**DEFENSE NUCLEAR FACILITIES
SAFETY BOARD**

Staff Report

Los Alamos National Laboratory Plutonium Facility Updated Leak Path Factor Analysis

SUBJECT: LANL PF-4 Updated Leak Path Factor Analysis

Figure 1. Leak path factor methodology and software packages

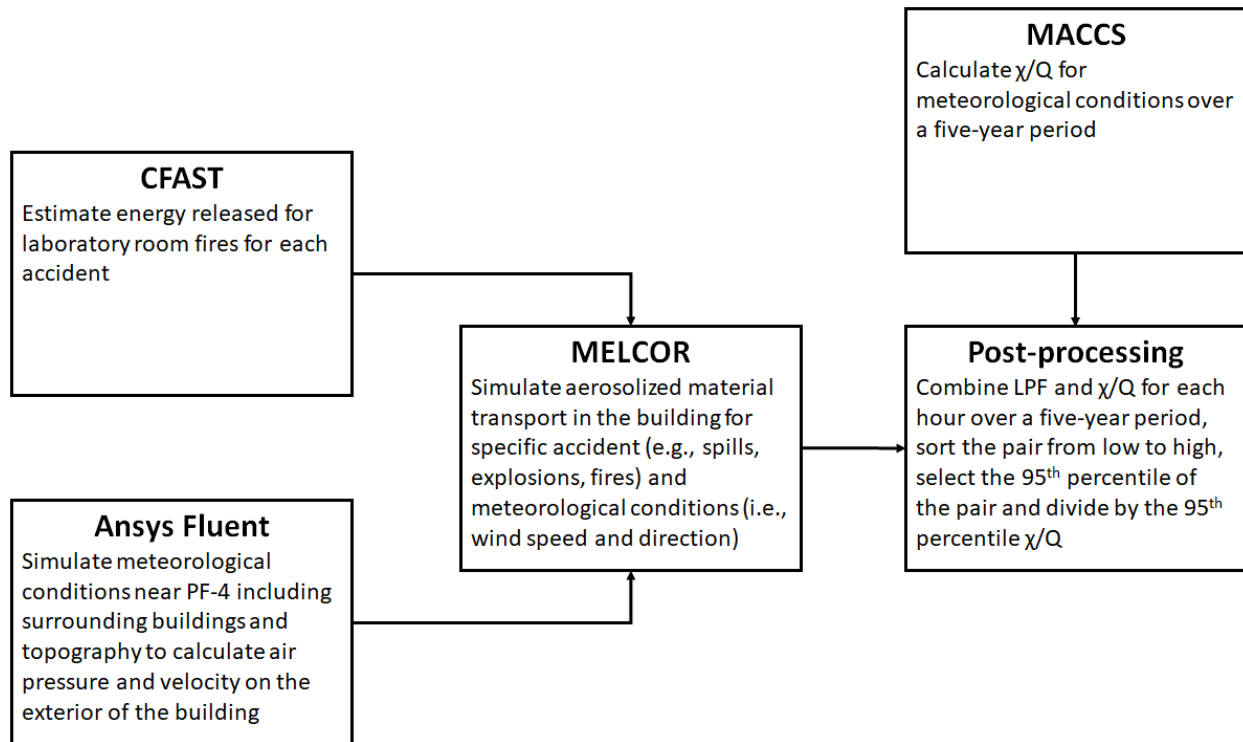
Based on the working papers and on discussions with Triad, the Board's staff found that the updated LPF methodology will have similar issues to the existing LPF methodology but will use different or updated software packages. The LPF methodology and software packages are described in Figure 1. Triad plans to use MELCOR version 2.2, which is newer than the version listed in the DOE Safety Software Central Registry¹ (version 1.8.5); Ansys Fluent release 19.0 (a

non- “toolbox” code); and CFAST version 7.1.1 (a “toolbox” code). For all safety software used, including software listed in the central registry, Triad personnel must ensure that the versions used meet software quality assurance requirements. The staff understands that Triad plans to provide supporting software quality assurance documentation for the code versions used in the final calculations.
